McLaren Senna – Left Engine High Temperature Radiator (HTR) Fan Wiring Harness Rework

Bulletin type:	Service Campaign
Reference number:	SCB 15 M 002
Attention:	Retailer Service Managers and Retailer Technicians
Affected vehicles:	McLaren Senna
Situation:	Potential for the Left HTR wiring harness to become loose from fixing points
Procedure:	To action affected vehicles during next Retailer visit. Please refer to the information outlined in this document to ensure the wiring harness is secure in its fixing points
Date:	6 th February 2020

Layout overview - Left HTR wiring location for required rework (1)
(extract from SCB 15 M 002 WI)

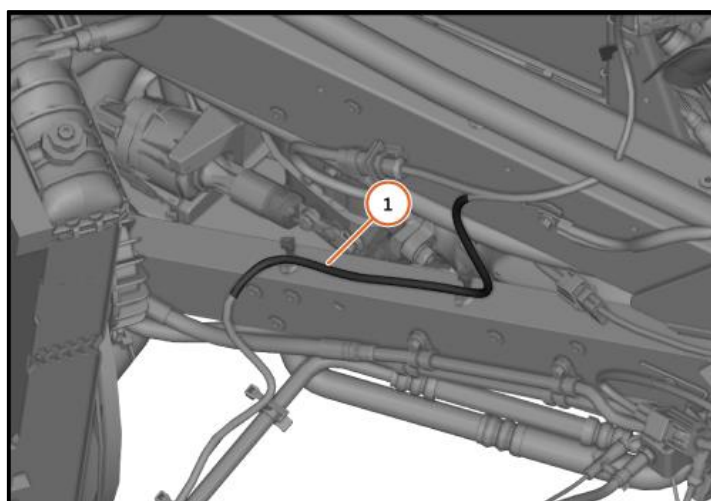
Through continuous product quality monitoring, it has been identified that a number of McLaren Senna vehicles may experience a concern where the Left Engine High Temperature Radiator (HTR) fan wiring harness becomes loose from its fixing points. This could cause damage to the components; therefore, a preventive rework solution has been released.

Document SCB 15 M 002 WI (attached with this Bulletin) contains the relevant work instructions and care points to ensure the repair is carried out correctly, bringing the vehicle up to the current manufacturing standard.
